VALUE ENGINEERING CHANGE PROPOSAL
MISSOURI DEPARTMENT OF TRANSPORTATION

☒ Conceptual Proposal ☐ Final Proposal Date 6-21-10
Contract ID 091218-408 Job No. J4I1382
County Clay I-35 Original Bid Cost 23,114,454.87
Contractor Idcker, Inc. By Cody Phillips
Designed By Gregory Anderson Phone 816-364-3970
VECP# 10-63 (to be completed by C.O.) VECP ☒ or PDVECP ☐

1. Description of existing requirements and proposed change(s). Advantages/Disadvantages
Proposed VECP to install French Drains in lieu of pipe aggregate edge drains in certain full depth areas on this project. The French Drain is an acceptable substitute and the advantages are that this will save time and money. Please see attached typical section.

TO: Perry Allen-4co
FROM: Greg Stervinou
Resident Engineer
DATE: June 25, 2010
SUBJECT: PDVECP 25% Share
Job No. J4I1382
Contract ID 091218-408
I-35, Clay County

AGGREGATE UNDERDRAIN

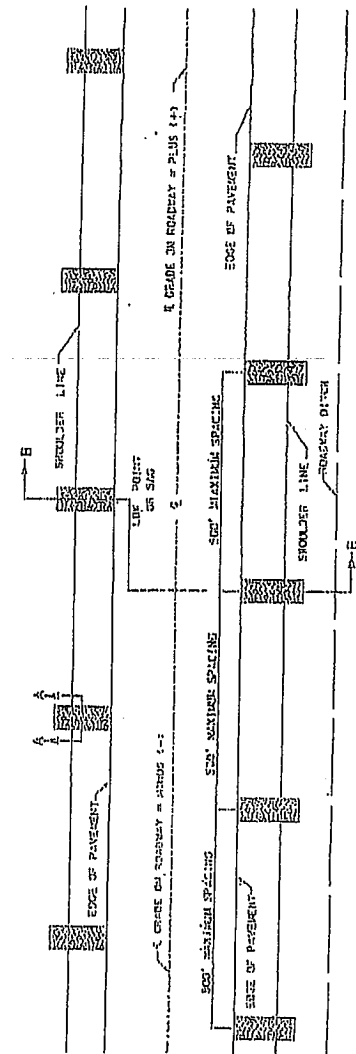
NOT AN EQUIVALENT FINISHED PRODUCT

- The VE proposal does not have drainage that is running parallel to the edge of pavement to carry water to each outlet
- The VE proposal does not allow the drains to be cleaned out
If the fines passing the 200 sieve are over 18% the drain will clog within a short period of time (5 yrs) and no way to clean them out and this can cause premature pavement failure.

Aggregate French drains were mostly intended (by us) as a retrofit treatment to moderately facilitate drainage in older pavements with trapped water. Newly constructed pavements can more fully benefit from the positive drainage features of an open pipe system.

This option was used on the I-35 project in D-1 and was accepted as a VE. Currently, the aggregate underdrains are functioning as designed.

On this project, the rubblized PCCP rock base extends under the full-width of the pavement and the A-2 shoulders, typically 38 feet wide. The finished grade typical section is a soil cap from the shoulder to the toe of the slope. The rubblized PCCP rock base is capped and sealed with millings in these full depth sections. In my opinion, the gradation of the rubblized PCCP (accepted by visual inspection) wouldn't clog the aggregate underdrains. The rubblized PCCP is already draining the pavement to the interface with the soil cap and then the underdrains are providing a conduit for this water to reach the ditch.

I am puzzled by the District's positive recommendation for this VE. The Project Manager and Central Office Pavement Specialist recommended against this VE, and additionally our pavement and materials specialist (Mike McGee) concurred with their recommendations after his review. Given the expertise involved and the valid concerns presented by these individuals, I do not concur with the VE proposal. Given these concerns, it would not be prudent to risk the long term drainage performance of this Interstate pavement to save \$70K to \$100K.
